Planning Statement

Planning Application reference P/24/0750 for Private Shared Access to serve housing together with replacement drainage to Neath Road and new footway and crossovers.

Old School Court, Neath Road, Bryn, Port Talbot

RESPONSE TO HIGHWAYS OBSERVATIONS DATED 12TH FEBRUARY 2025

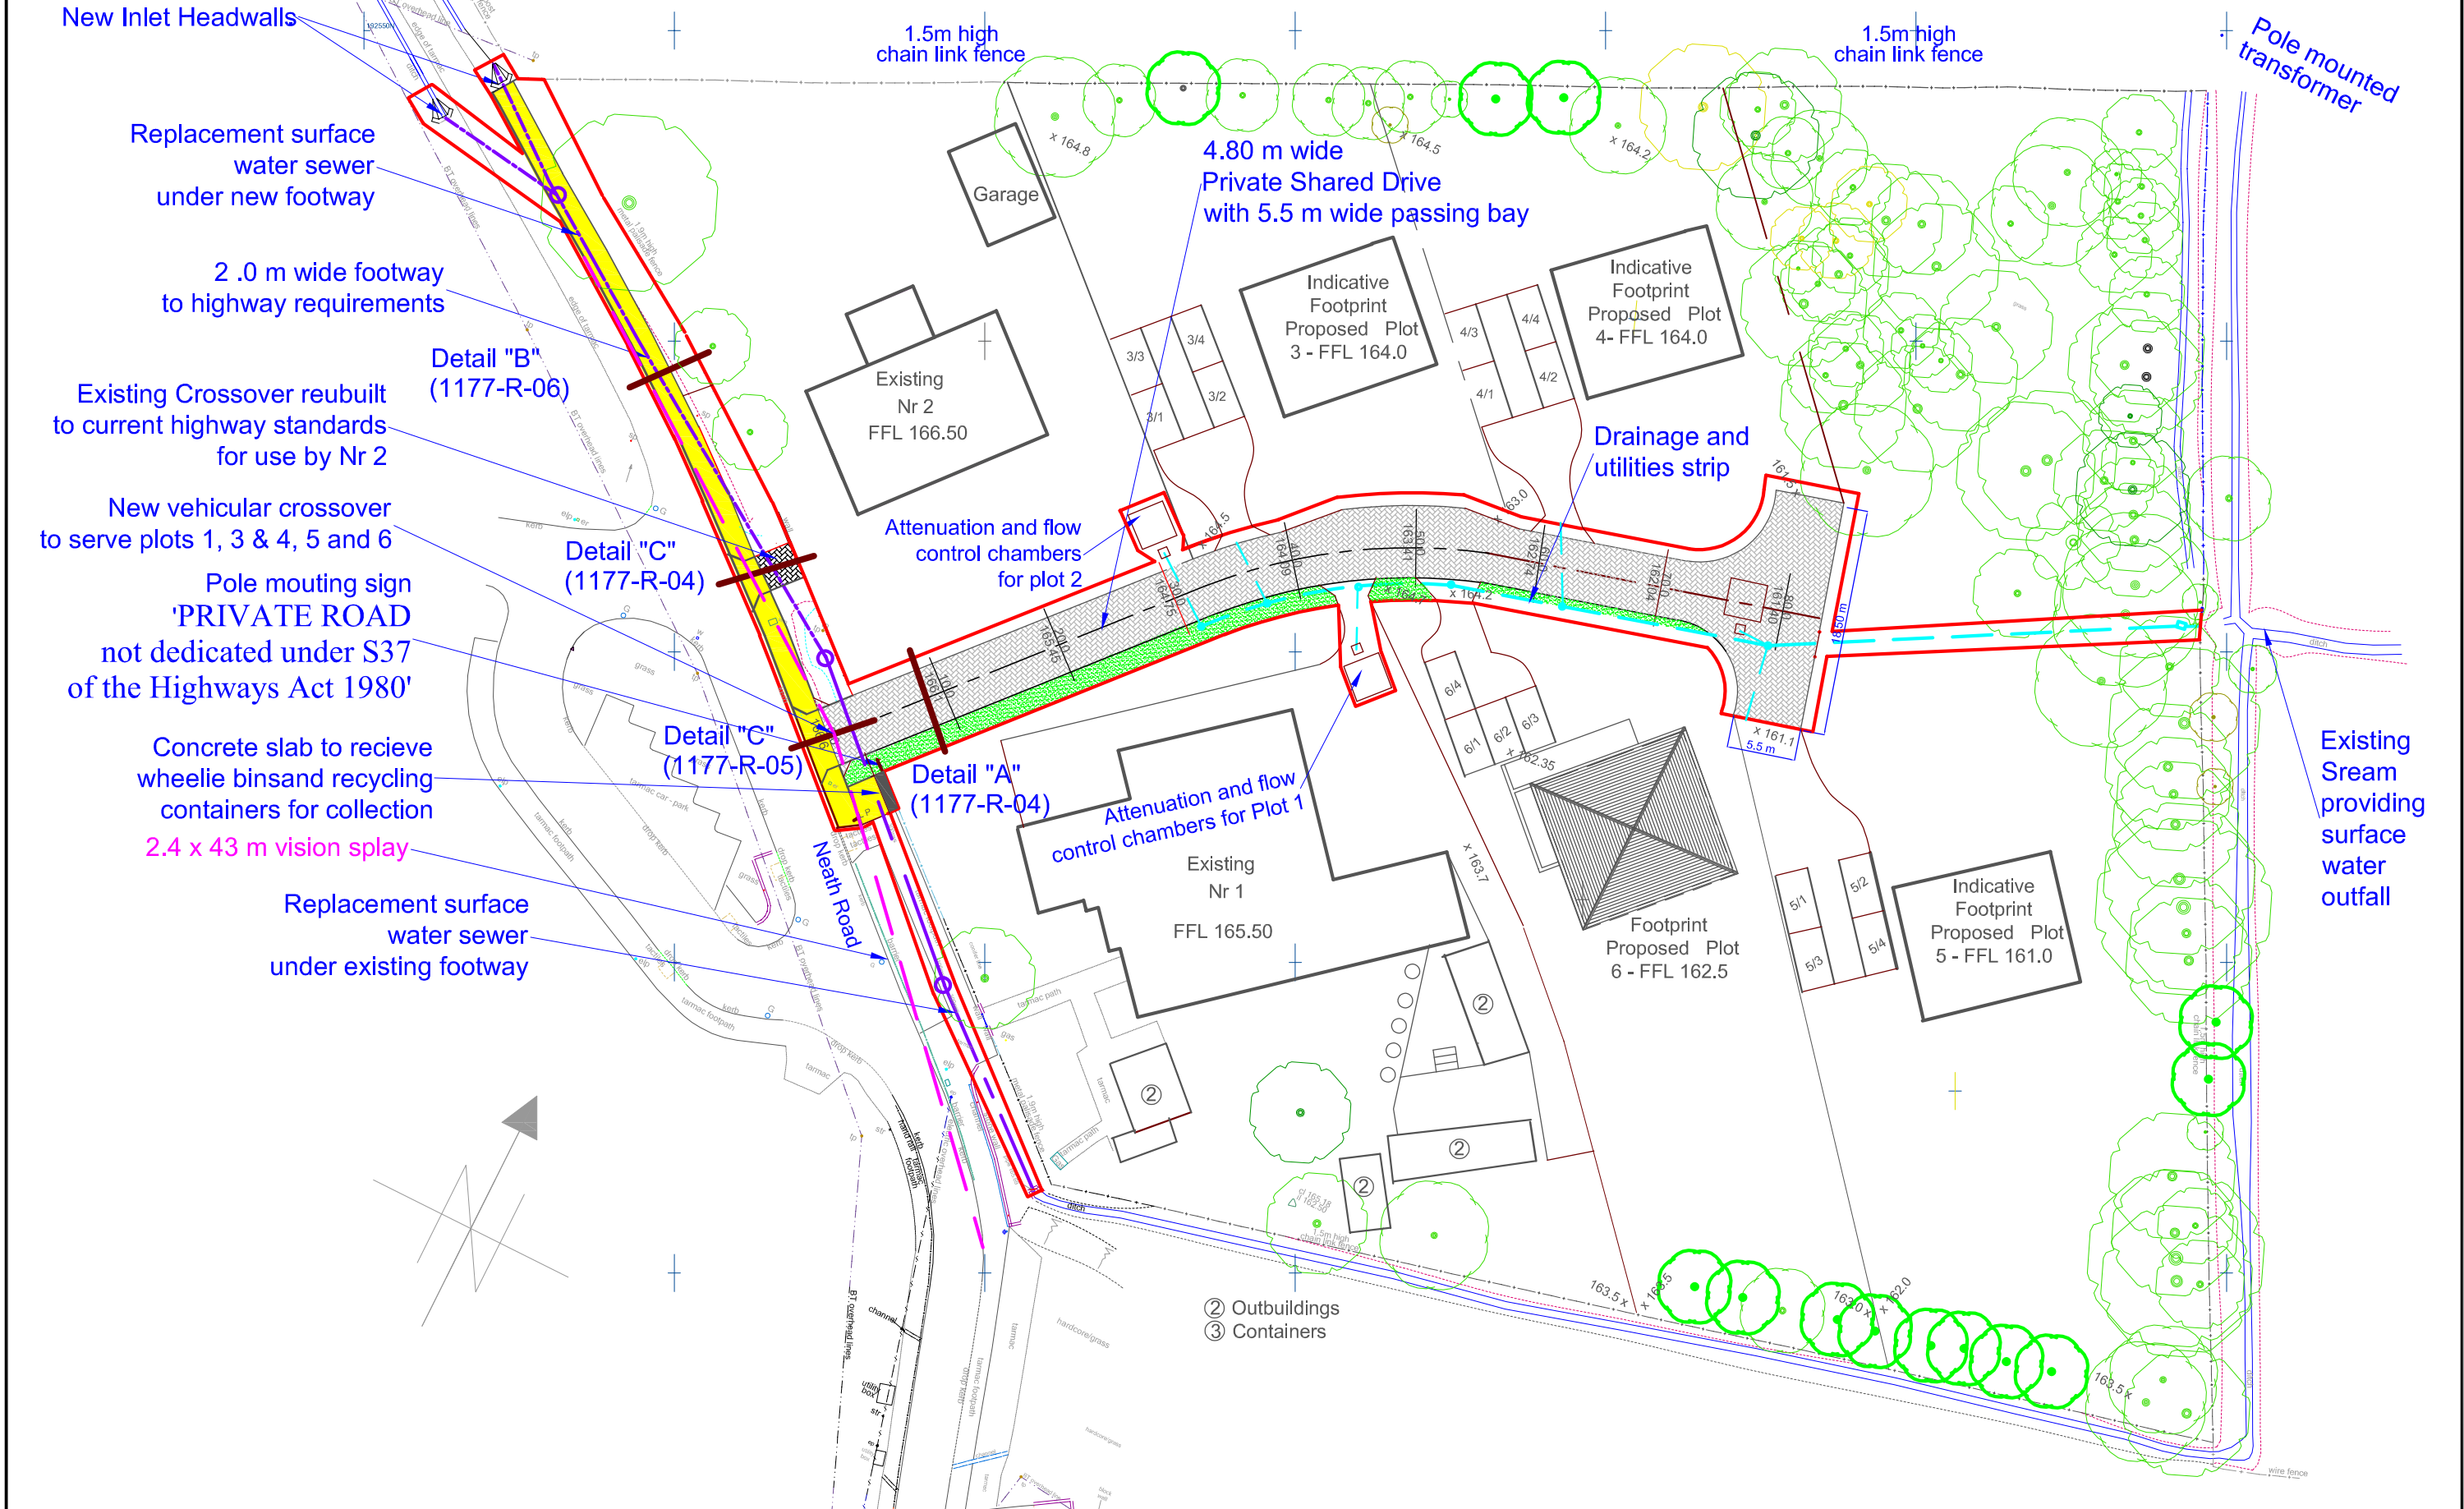
1. *All shared drives (serving a maximum of 5 dwellings) as annotated on drawing 1177-R-03 Rev B stating “new vehicle crossover to serve 3&4, together with plots 1, 5& 6” shall have a gradient not exceeding 1 in 9 and are to have vision splays onto Neath Road of 2.4m by 43m, pedestrian vision splays of 2.4m by 2.4m (behind footway) which should be hard surfaced. The shared drive shall be provided with a turning facility so all vehicles can enter and leave in a forward gear.*

2. ***Shared drives should not exceed 25m in length (carrying distance for bins from each dwelling) where shared drives are present, there will be a need to widen the footway or provide a bin parking area to the rear of the adoptable highway where bins/sacks can be placed on collection day without obstructing the footway.***

4. ***The main access road measuring in excess of 80 meters exceeds NPTCBC's 25m guidance for Shared Driveways. This access road shall be upgraded from a 'Shared Drive' to an Adoptable Standard with a minimum road width of 5.5m. A surfaced and lit footway measuring 2m in width is to be provided along the frontage of each property and must be extended around any turning heads.***

- 9. Any areas of Shared driveways will not be adopted and responsibility for maintenance must be clearly defined. Whereby detailed signage shall be submitted to and approved in writing by the LPA, the approved sign shall erected at the entrance of the shared drive on private land, not public ally maintained highway, stating the following in English and Welsh ‘PRIVATE ROAD with no intention to dedicate under S37 of the Highways Act 1980’ the signage as approved shall be constructed on site prior to the occupation of the first dwelling.**

- 11. A swept path analysis should be provided for any junctions and turning areas for the movement of emergency, refuse, recycling and delivery vehicles.**

a) Drawing 1177-R-03-D shows the proposed finished levels of the Private Shared Drive at 10 metre intervals. The steepest gradient is 0.7m between Chainage 20-30 and 60-70 (1 in 14.3). This is far less than the minimum requirement.

b) Vision splays to the existing highway of 2.4m x 43m have been added to drawing 1177-R-03-D.

c) The paved area of the shared private drive has been amended to provide the 1.0m x 1.0m vision splays shown on Technical Specification 104 listed on The Highway Technical Design Guide published on the Council's website. A copy of specification 104 was issued to the Planning Agent under cover of the Council's e-mail dated 17th April 2025.

d) A turning facility has been provided on drawing 1177-R-03-C. This is set out in accordance with Technical Specification 105 as listed on The Highway Technical Design Guide published on the Council's website. A copy of specification 105 was also issued to the Planning Agent under cover of the Council's e-mail dated 17th April 2025.

a) The Council's Technical Specification 104 limits a Private Shared Drive to 45m without passing spaces or a turning circle for large delivery or service vehicles. The council's Technical Specification 105 allows longer private drives conditional on the provision that passing bays and turning facilities for larger delivery or service vehicles. The proposed Private Shared Drive shown on drawing 11773-R-3-D conforms to the requirements of both these documents.

Technical Specifications 104 and 105 form part of the Council's Highway Technical Design Guide published on the Council's website. These documents clearly allow for Shared Private Shared Drives as shown on drawing 1177-R-03-D for 5 properties. Therefore an adoptable standard road is not required in this case.

Splays 1.0 x 1.0 shown provided on previously supplied copy of drawing 1177-R03 and revision D of that drawing which accompanies this statement.

A note regarding suitable signage has been added to drawing 1177-R-03-D

The turning area shown on drawing 1177-R-03-D has been prepared to conform to one of the turning areas shown on Specification 105. This drawing states at item 2 “Variations may be proposed as long as a swept path analysis is provided to ensure service and delivery vehicles can turn”. Therefore it is assumed that no swept path analysis is required.
